A585 Windy Harbour to Skippool Improvement Scheme

7.11 Environmental Statement Changes and Corrections Document

Environmental Statement Changes and Corrections Document

Regulation Number:	Regulation 5(2)(q)
Planning Inspectorate Scheme Reference	TR010035
Application Document Reference	TR010035/APP/7.11
Author:	A585 Windy Harbour to Skippool Improvement Scheme Project Team, Highways England

Status	DEADLINE 2 SUBMISSION	Revision	1
Scale	1:2500 A3	Date	MAY 2019
Drawn By	J.NORMAN	Checked By	K.BURROWS
Approved By	N.HENDERSON		
PINS No.	TR010035	FIGURE	11.4
Drawing number	HE548643-ARC-EGN-SZ_ZZ_000-DR-LE-30

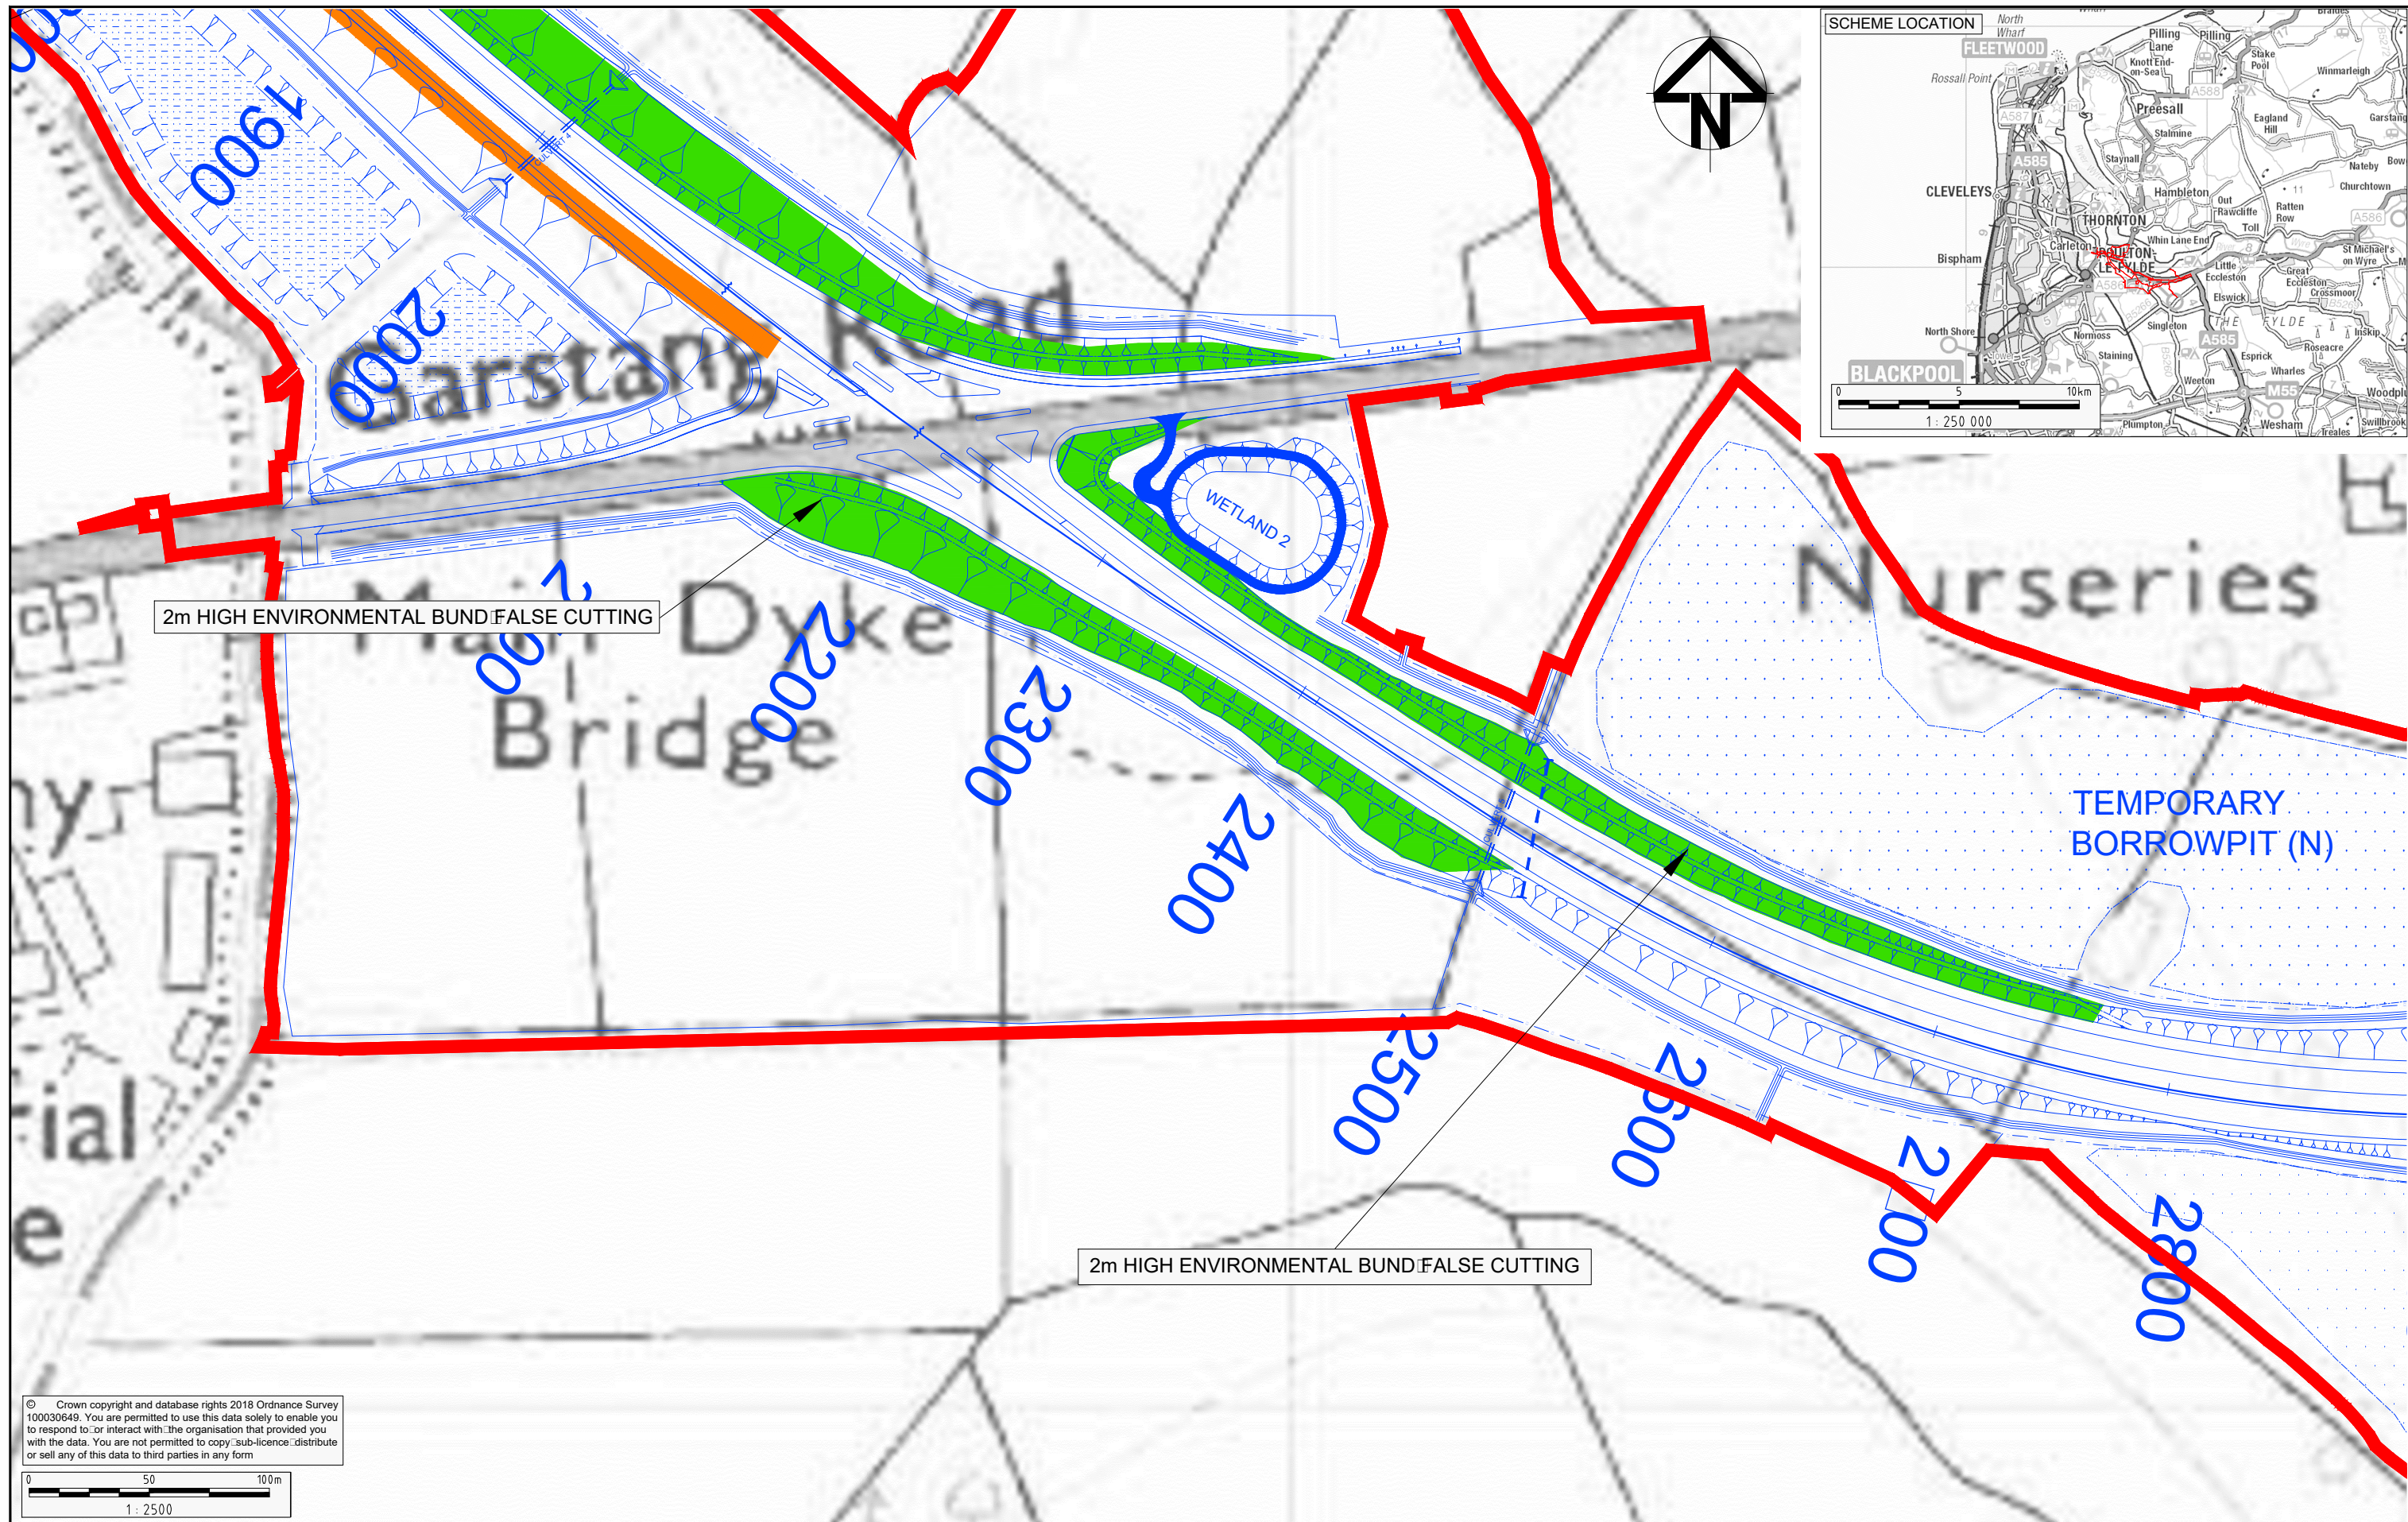
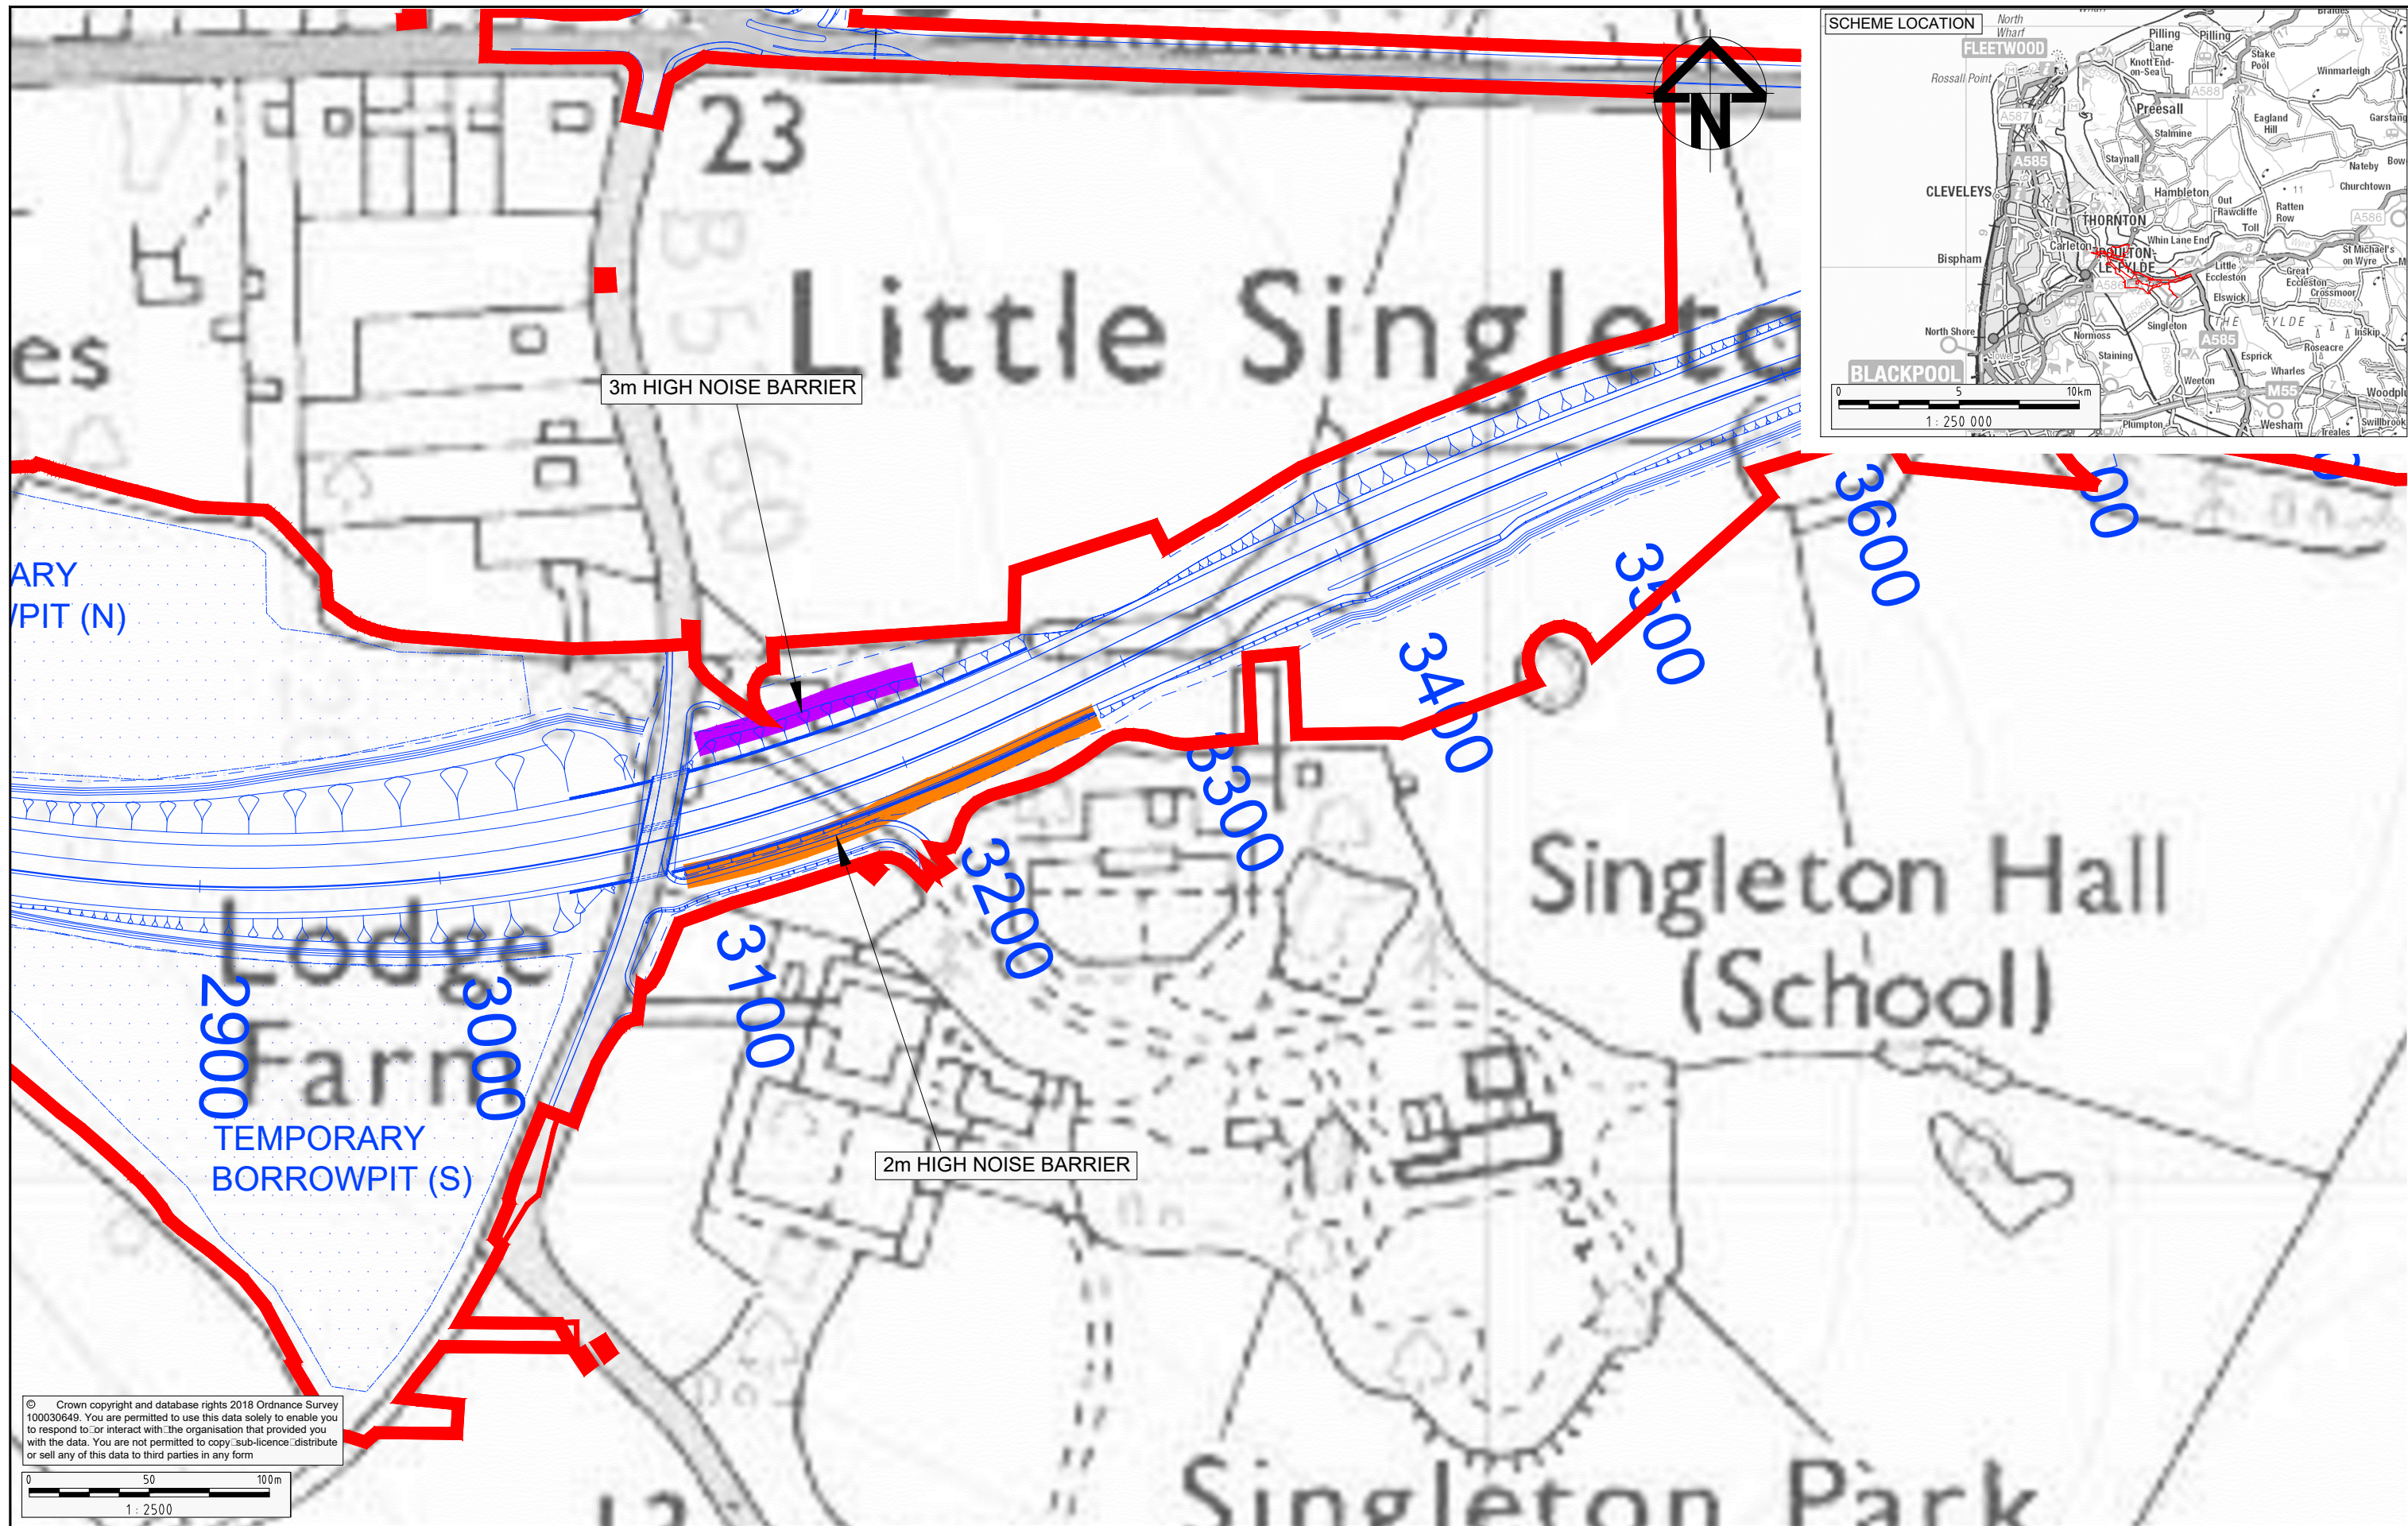
Document Reference Number	Document Name	Amendment Required	Reason
			TR010035/APP/7.10).
6.11	ES Chapter 11: Noise and Vibration	Update to Figure 11.4: Noise and Vibration – Noise Mitigation within the Study Area presented at Appendix D to show heights and locations of earth mounds and acoustic fencing at a larger scale.	Requested by the Inspector within the first round of written questions (document reference TR010035/APP/7.10).

Drawing Title: **ENVIRONMENTAL STATEMENT REGULATION 5(2)(a) NOISE AND VIBRATION: NOISE MONITORING LOCATIONS WITHIN STUDY AREA**

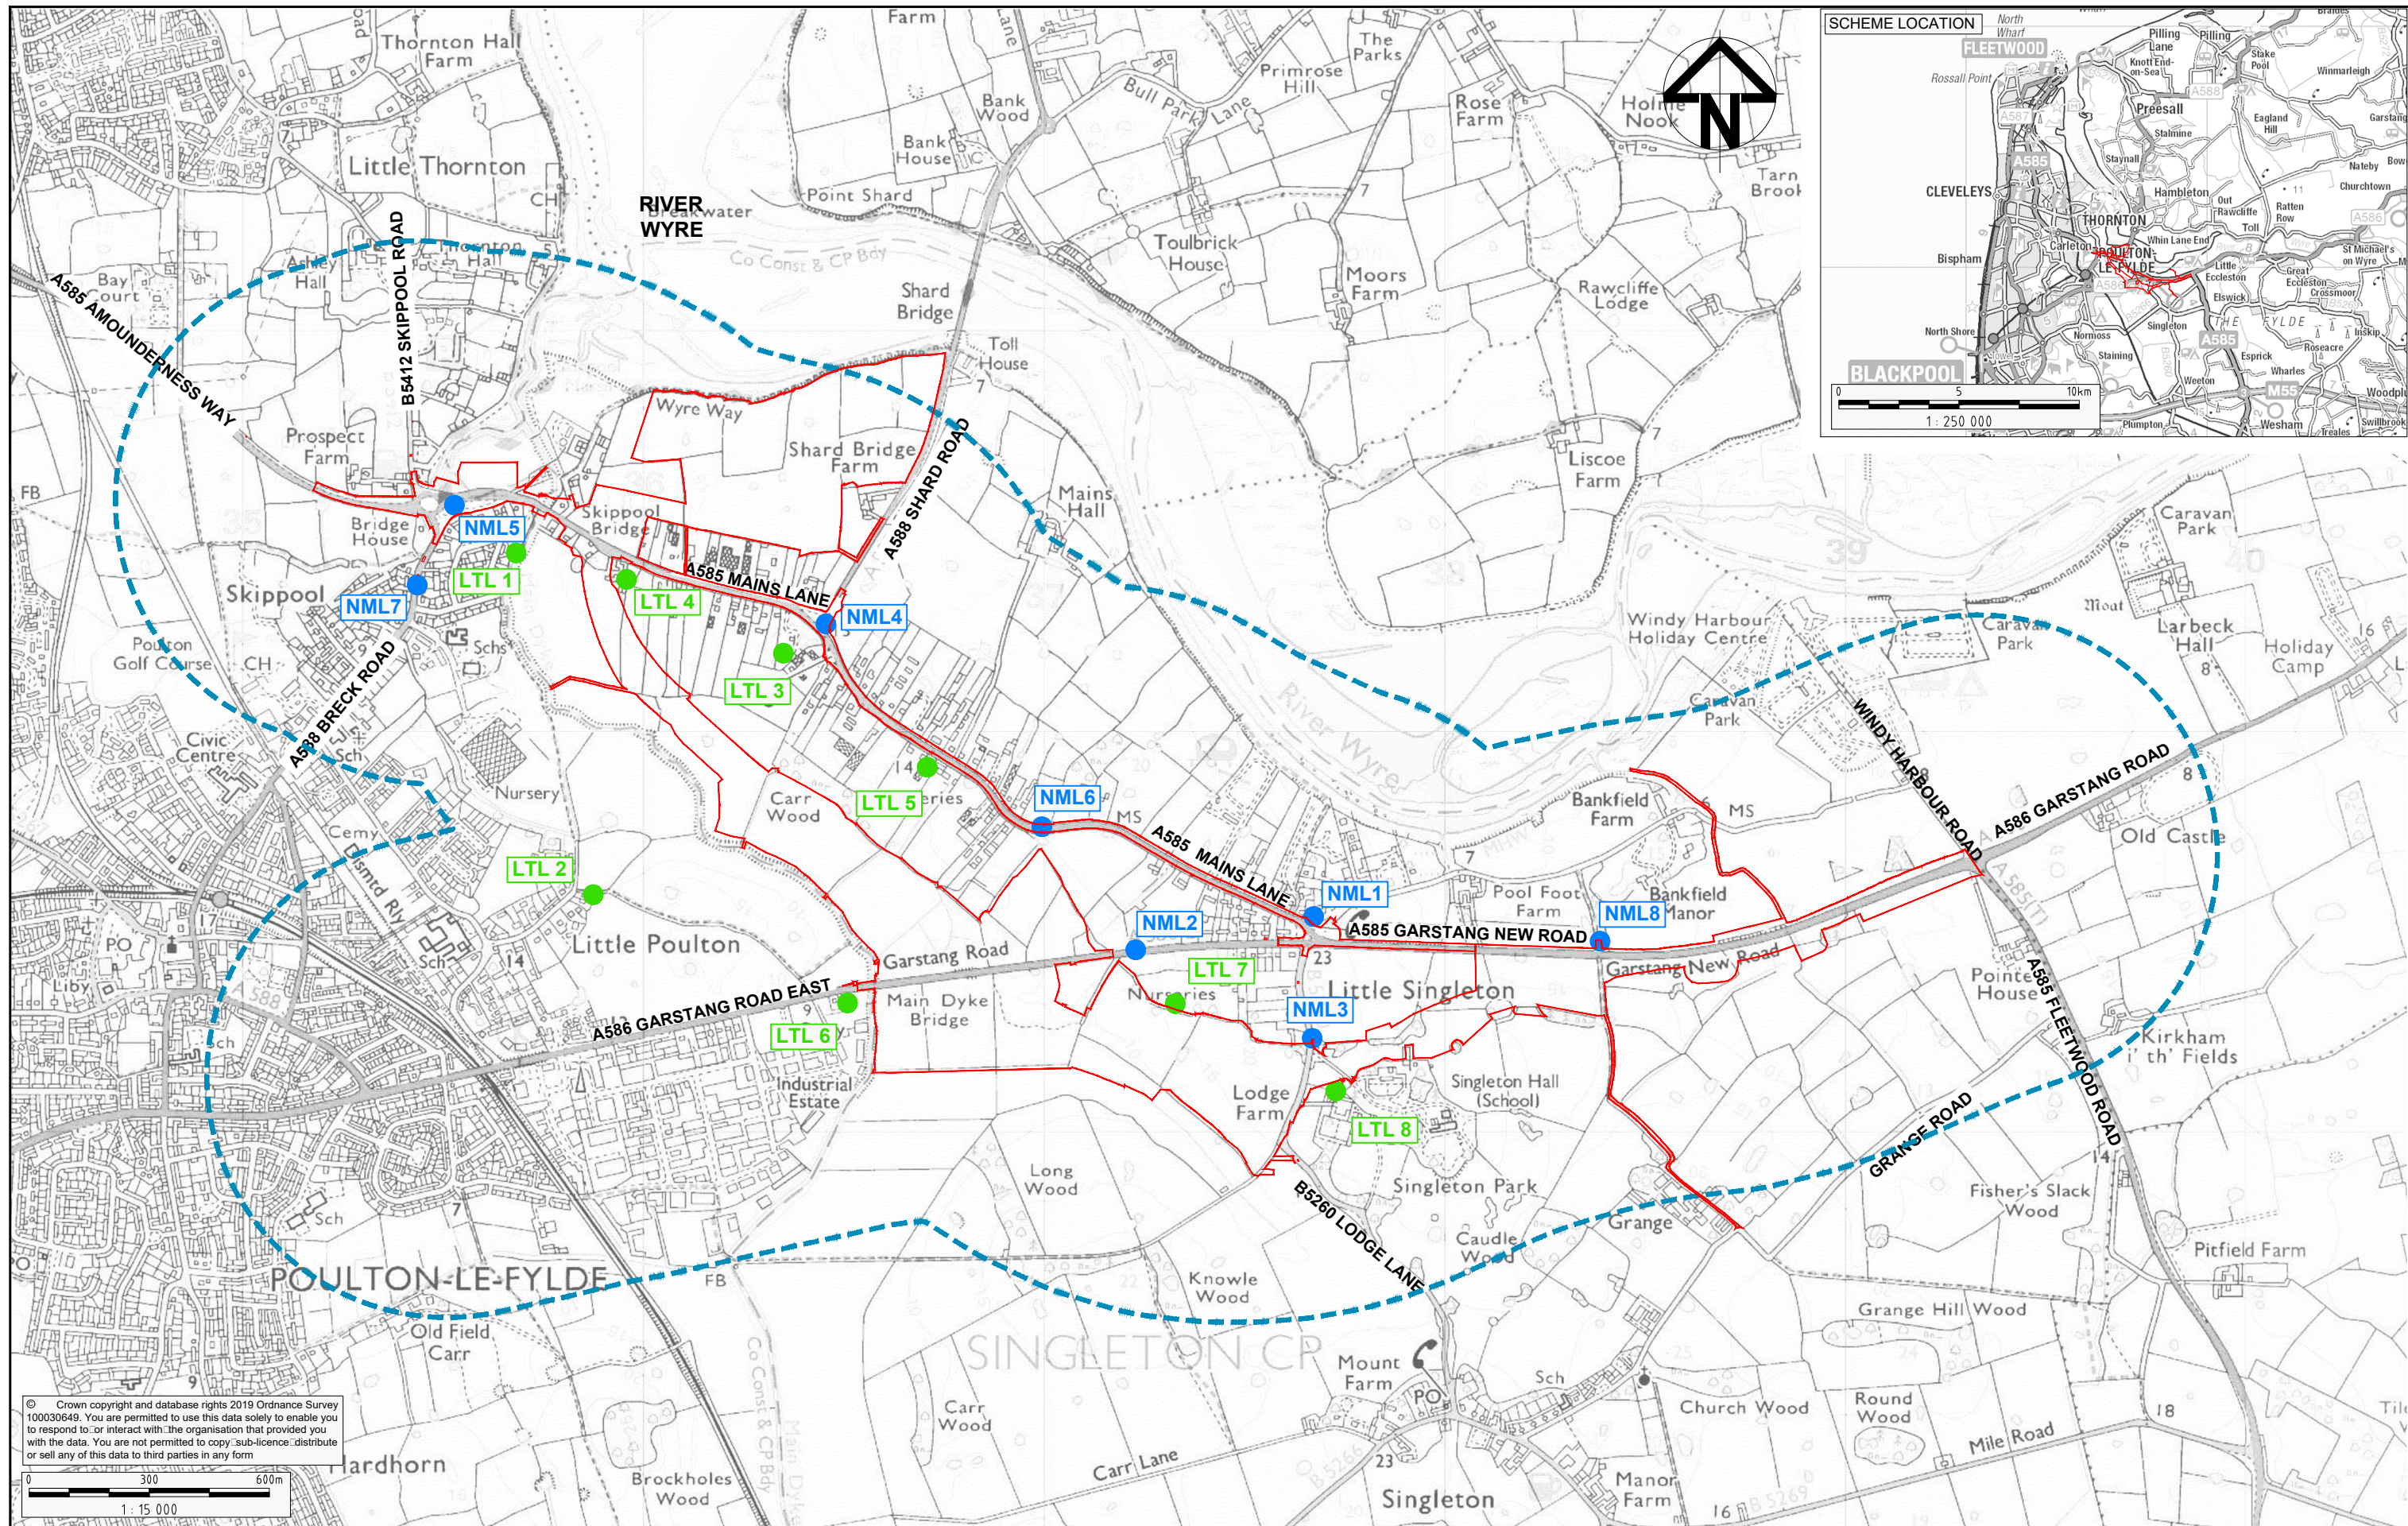
6.11	ES Chapter 11: Noise and Vibration	Update to Figure 11.1: Noise and Vibration – Noise Monitoring within the Study Area presented at Appendix D to show the locations of the eight attended noise surveys.	Requested by the Inspector within the first round of written questions (document reference
